S E R V I C E N O T E

**E4401B, E4402B, E4403B, E4404B, E4405B, E4407B, E4408B, and E4411B ESA Spectrum Analyzer family. Also E7401A, E7402A, E7403A, E7404A, and E7405A EMC Pre-Compliance Analyzers.**

**Intermittent screen "flicker" due to a cold solder joint**

**Figure 1**

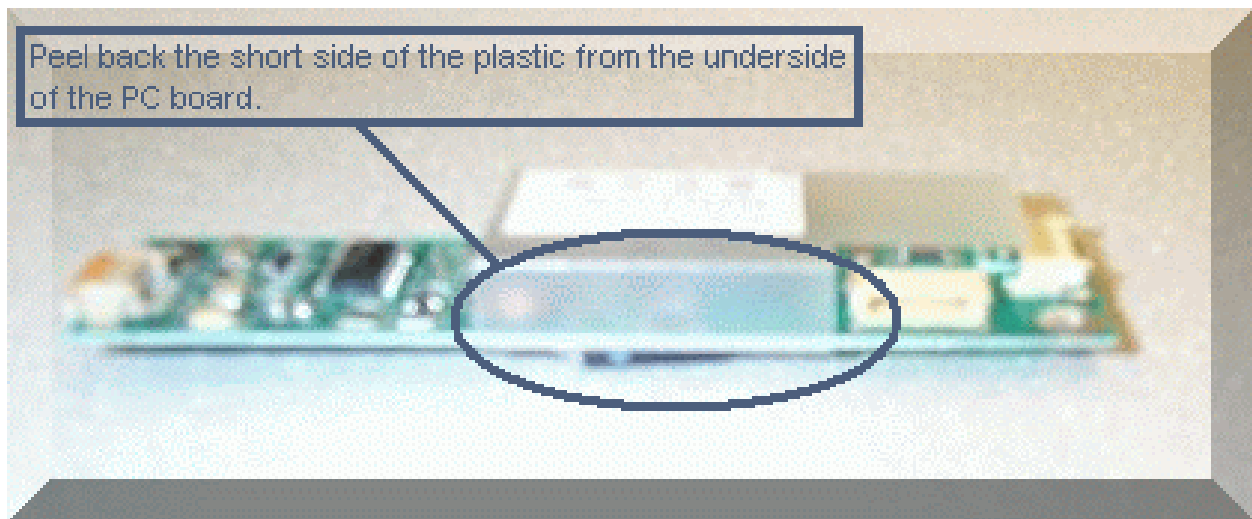
Instruments within the above serial range can experience an intermittent screen "flicker" due to a cold solder joint on pin 7 of the transformer on the backlight inverter board. The backlight inverter board attaches to the front panel interface board (A1A1) on the analyzer. The attached figures below in the Solution/Action section can be referenced on the procedure to use to correct for this problem.

- 1) Peel back the plastic shield on the backlight inverter board. See Figure 1.

**Figure 2**

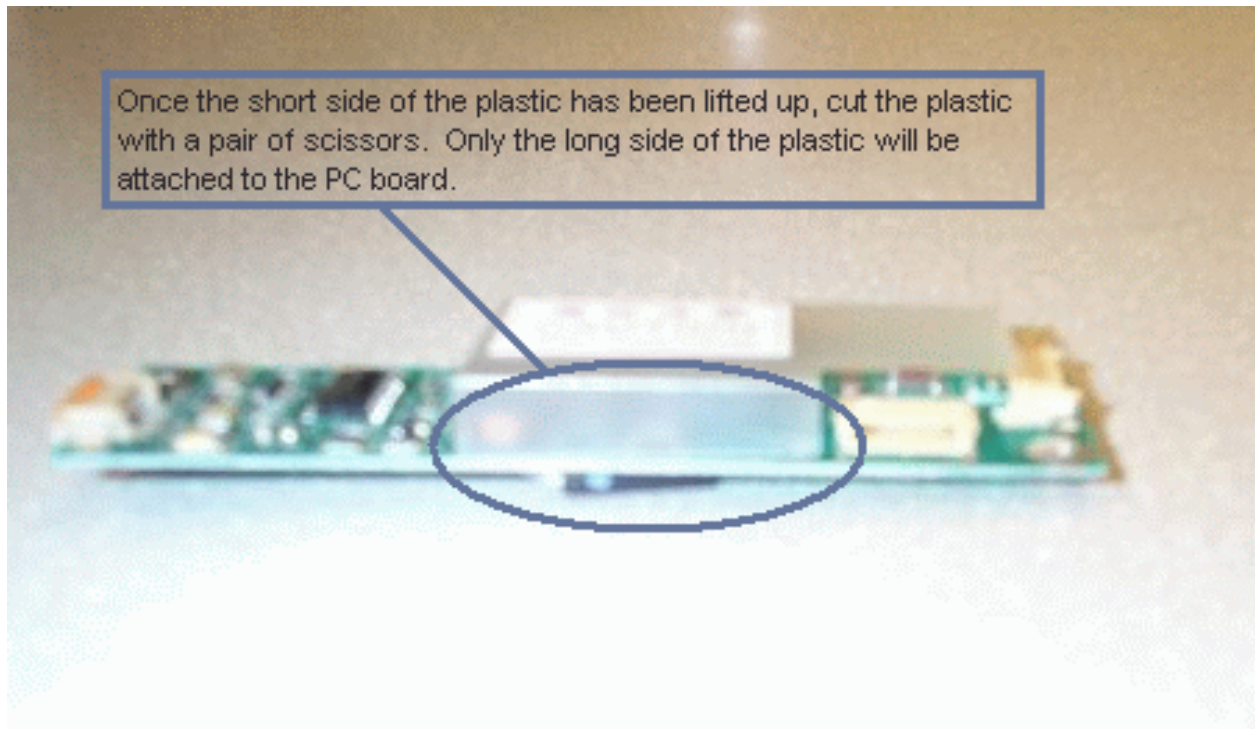
- 2) Cut the plastic with a pair of scissors. See Figure 2.

**Figure 3**

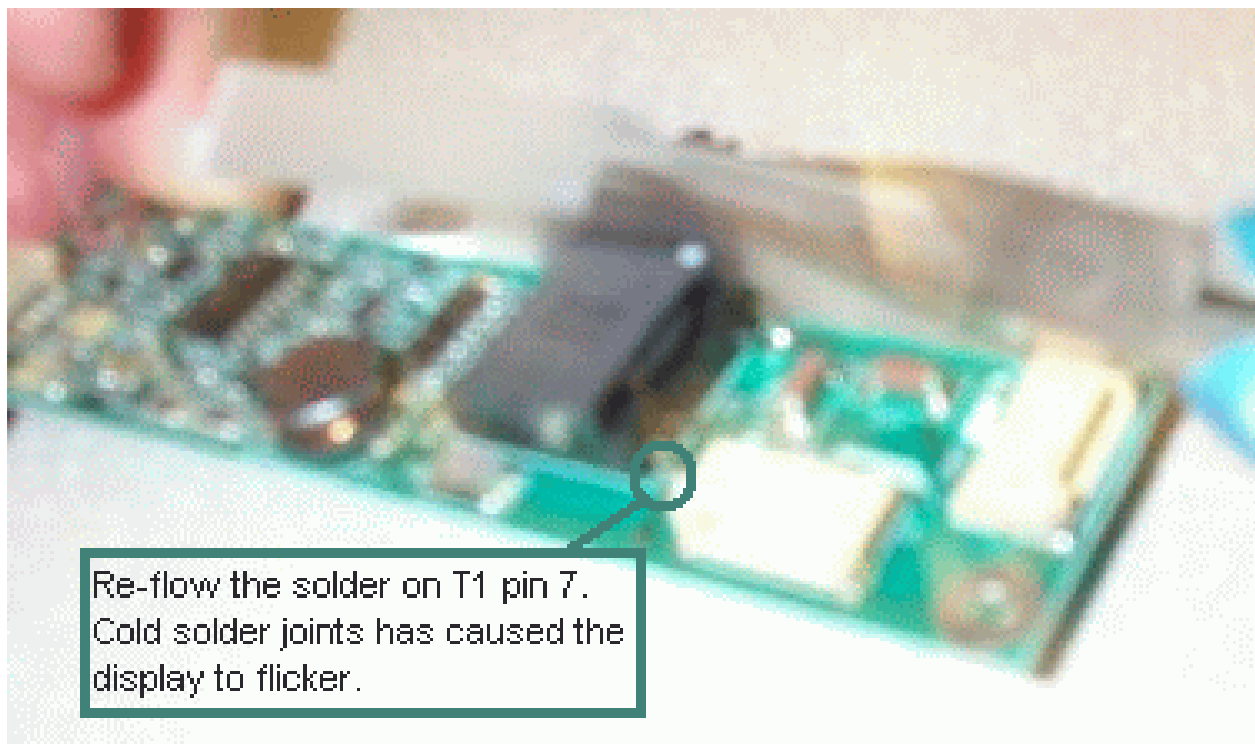
3) Re-solder pin 7 of the transformer on the backlight inverter board. See Figure 3.
